# PRODUCT CHANGE NOTIFICATION

## Bourns® Model SRR1280A Series Shielded Power Inductors

### *Change to Inductor Core, Shield Design and Material*

**New Inductor Core Design - Smaller B dimension**

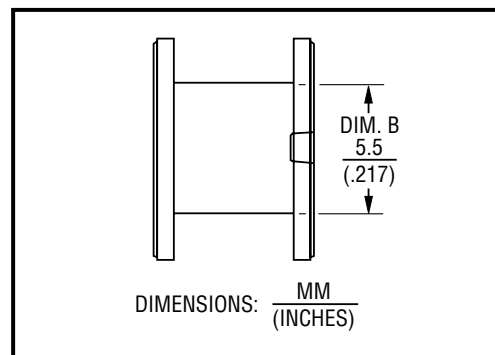
Riverside, California – August 24, 2021 – Effective March 19, 2022, Bourns will change the inductor core and shield design for the [Model SRR1280A Series Shielded Power Inductors](#). The modified inductor core will have a slightly smaller center pole diameter. The modified shield will have a slightly higher wall and larger center radius. These modifications will allow better core and shield alignment in the assembly to improve the quality and performance of the inductor.
